Baldwin County Planning Commission Staff Report

Case No. SPP25-38

Benjamins Run

September 3, 2026

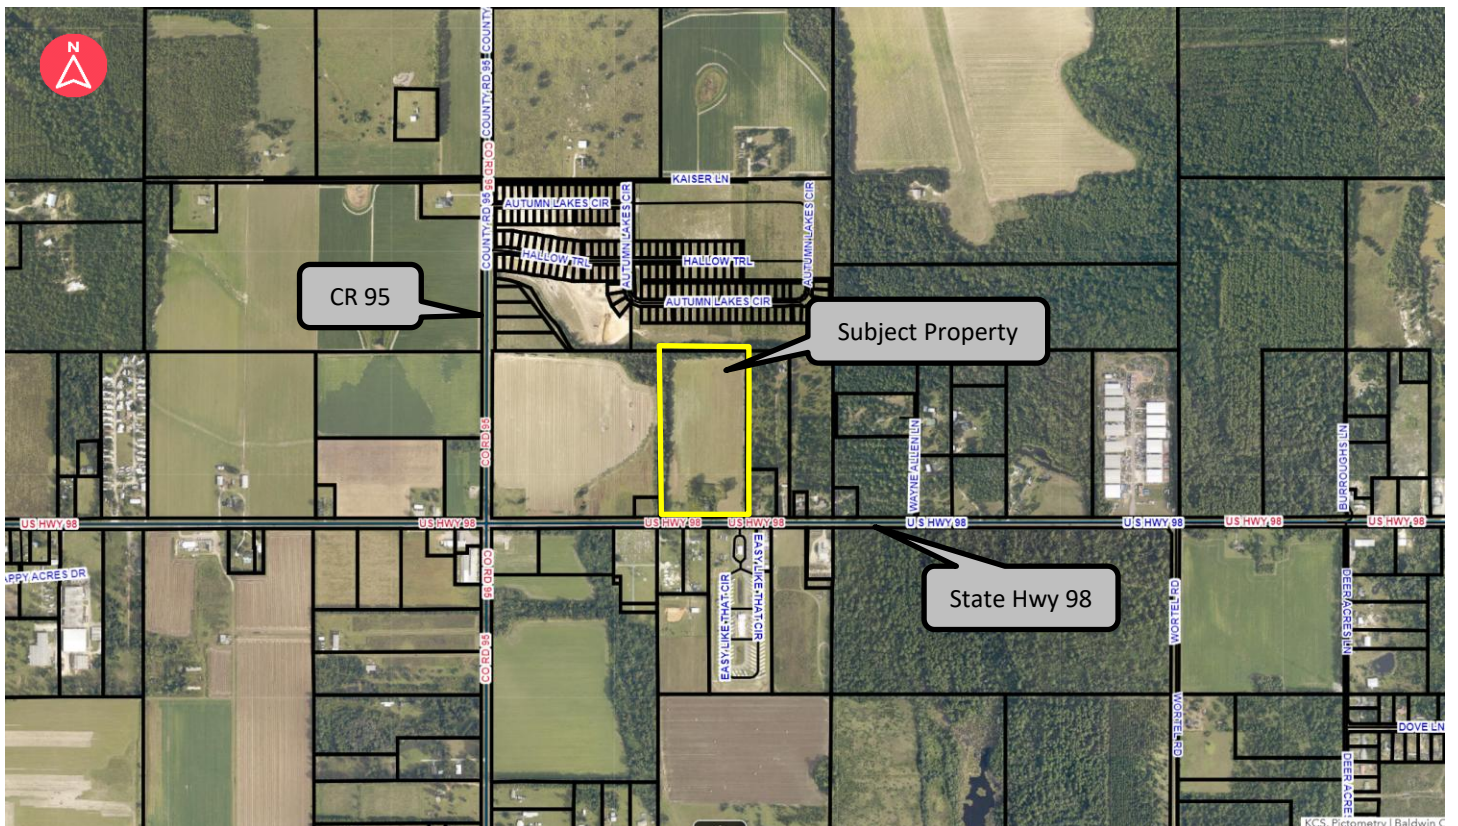
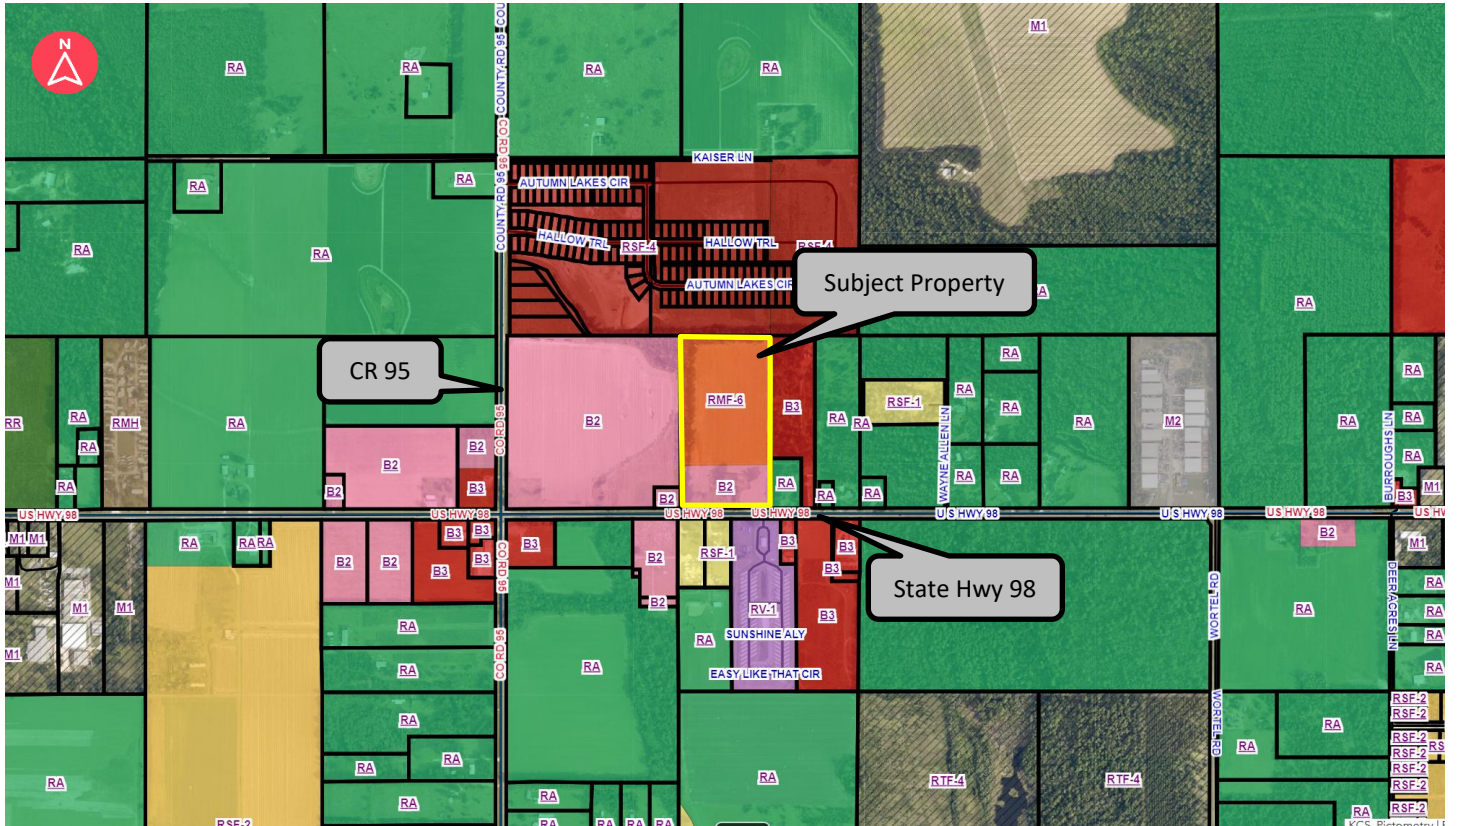
Staff has reviewed the proposed development for compliance with the Baldwin County Subdivision Regulations and applicable zoning requirements. The proposed density is consistent with the underlying RMF-6 zoning district, and the site plan provides the required open space areas and common areas necessary to serve the development. The development utilizes private streets that are proposed to remain under private ownership and maintenance and will require approval by the Baldwin County Commission prior to final plat approval.

The access for the proposed development will be permitted through ALDOT.

Staff recommend that the PRELIMINARY PLAT for Case No. SPP25-38 Benjamins Run be **Approved with conditions** subject to compliance with the Baldwin County Subdivision Regulations

1. Approval of the Preliminary Plat does not constitute approval of the proposed private road system. The applicant shall obtain County Commission approval of the private road request prior to Final Plat approval.
2. Applicant shall construct all roadway improvements identified in the accepted traffic study, including turn lanes and roadway widening improvements, prior to submitting a Final Plat application
